## **Final Acceptance (FA) – Punchlist from EPC Stormwater**

Project Name:	Winding Walk Filing 1
PCD Filing Number:	SF182
ESQ #:	ESQ187
EPC Stormwater Personnel:	Christina Prete, Dylan Finley and Joshua Augustenborg
Date of Walk-Thru:	10/10/2022
PA Walk-Thru #:	12/02/2019 (PCD Only)

Photo 8: South trickle channel needs repair at Pond E

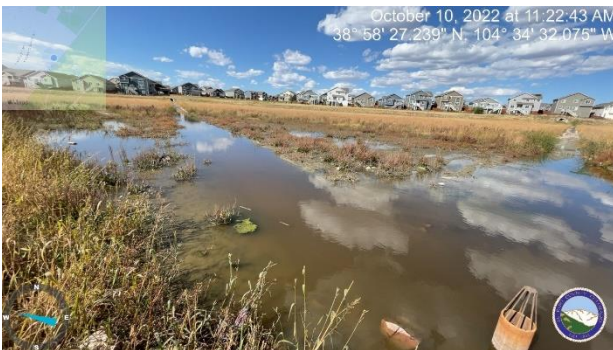
- The South trickle channel is damaged and will need to be repaired.
- Outlet riprap protection is not adequate and should be installed per plan (see Construction Drawings Sheet 20).

Photo 18: Storm #7 outlet needs to be cleaned and temporary BMPs removed.

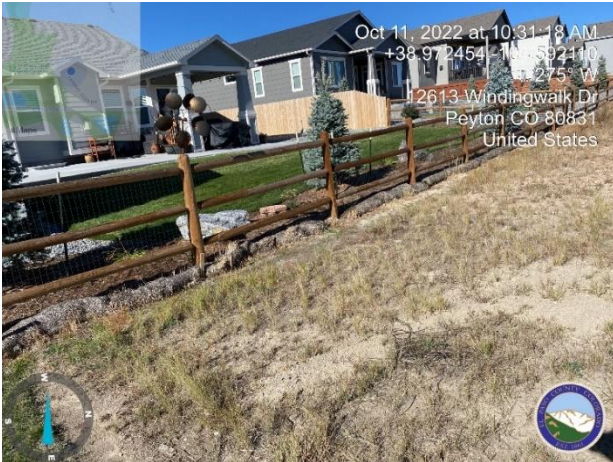
- Storm #1, Storm #4, Storm #7 inlets must be cleaned out and temporary BMPs removed.
- Fine grade outlet riprap at Storm #7 to promote positive drainage.
